SUBJECT: Friendship Village
 MnDOT Review P17-031A
 SE quad US169 and I-494
 Bloomington, Hennepin County
 Control Section 2776

PHASE 1 NORTH LANDSCAPE PLAN

SUBJECT: Friendship Village
 MnDOT Review P17-031B
 SE quad US169 and I-494
 Bloomington, Hennepin County
 Control Section 2776

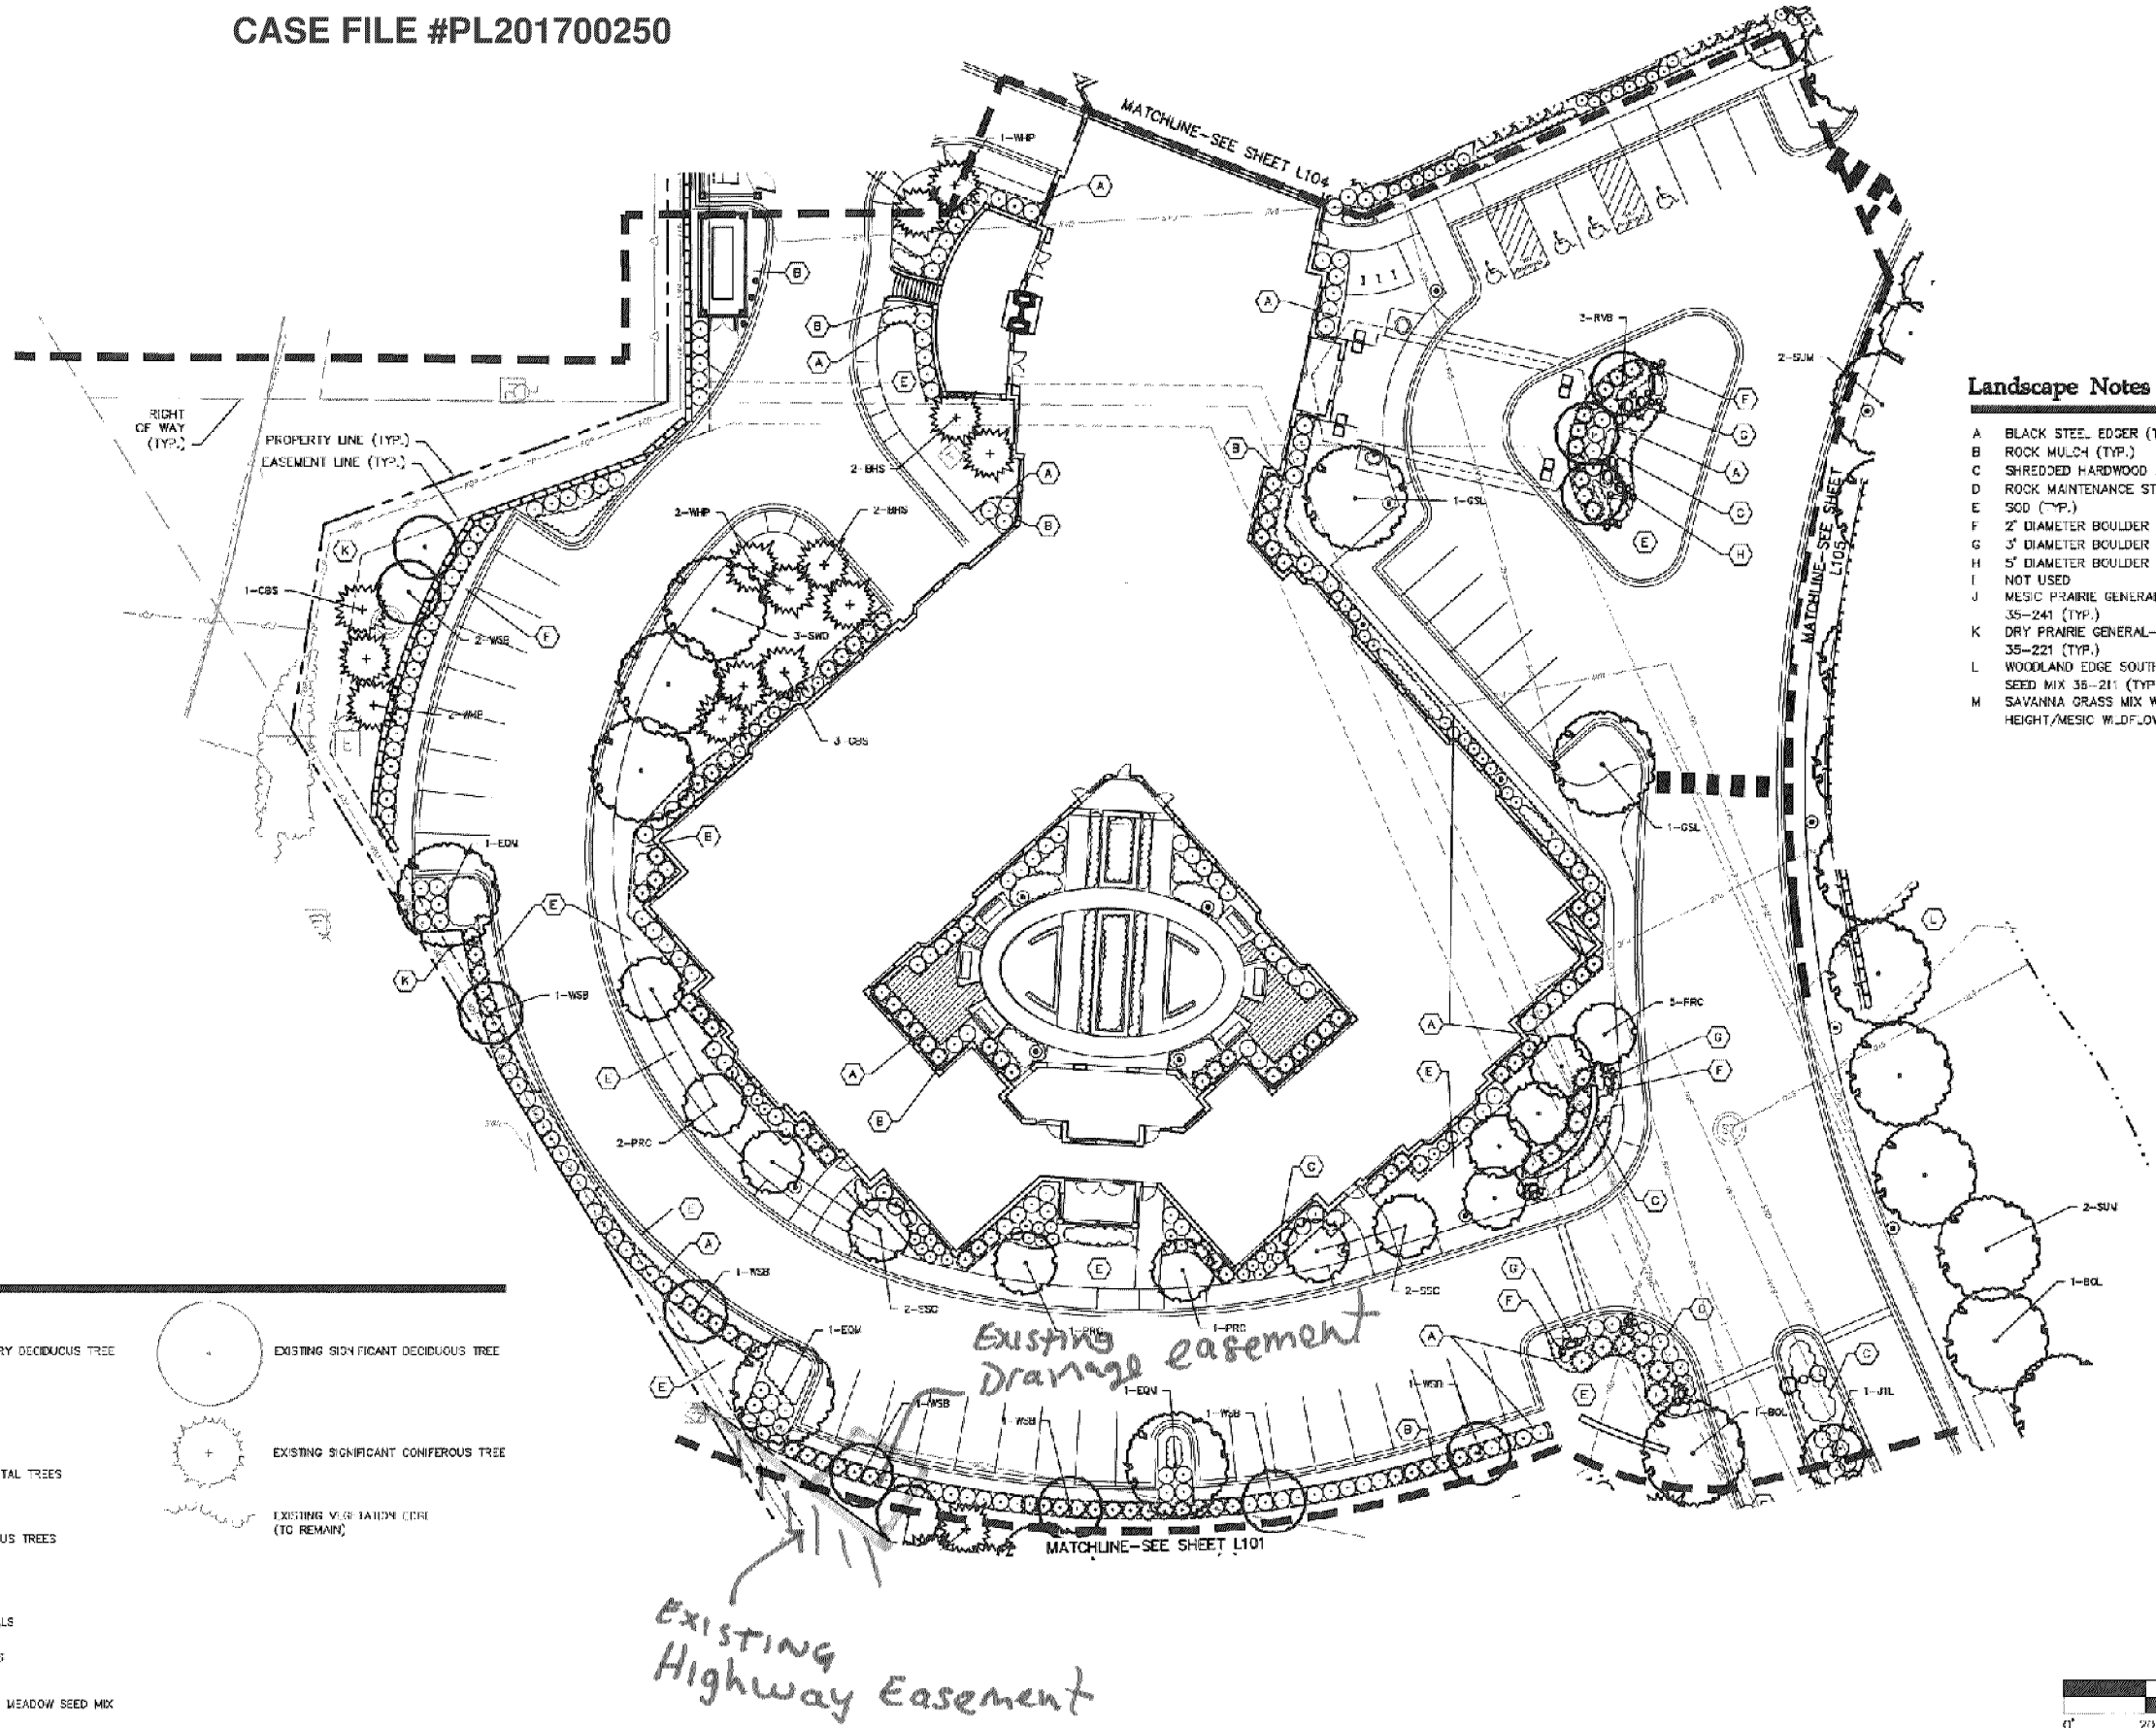
Please label the drainage easement on the plans, refer to the attached sheets marking the easements.

PROTECTION AND RESTORATION OF VEGETATION

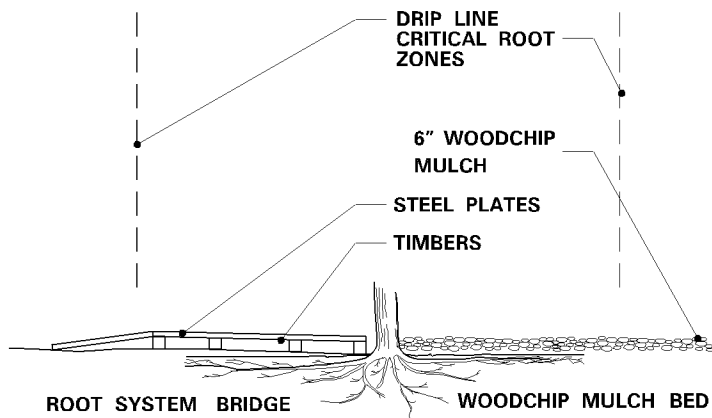
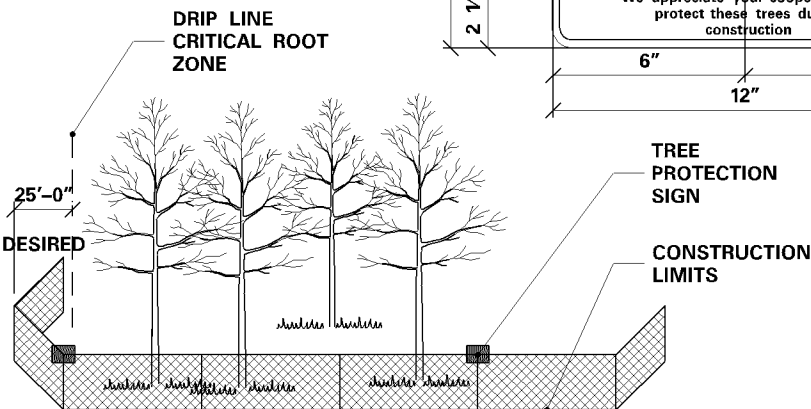
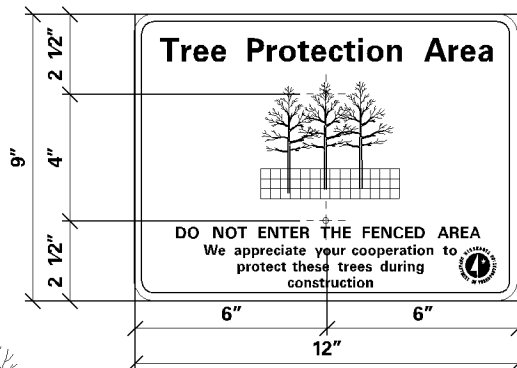
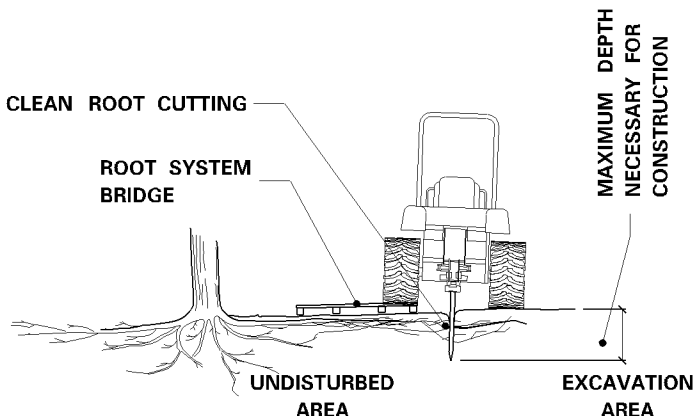
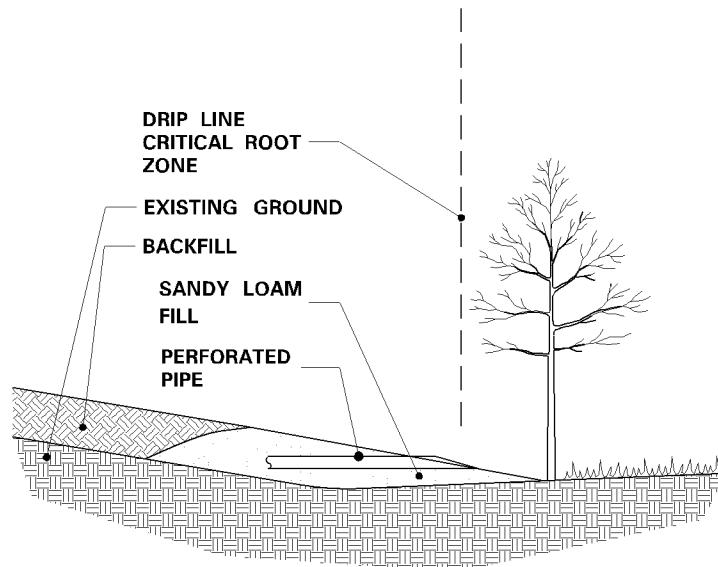
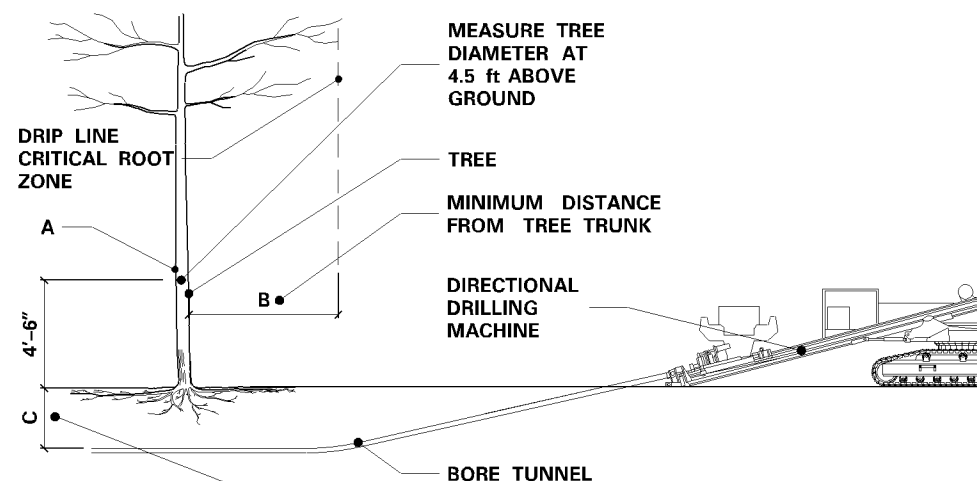
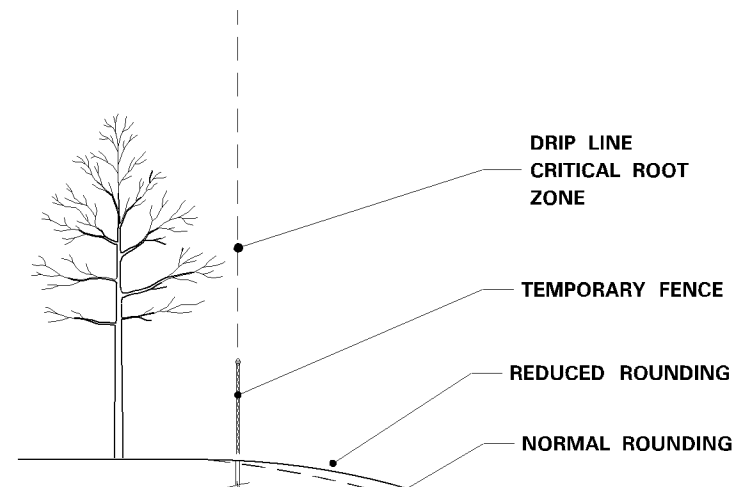
The trees on MnDOT right-of-way will need to be protected during construction. The protection around the tree will need to be to the drip line, even if that is on private property. Please reference the attached sheet for details on tree protection.
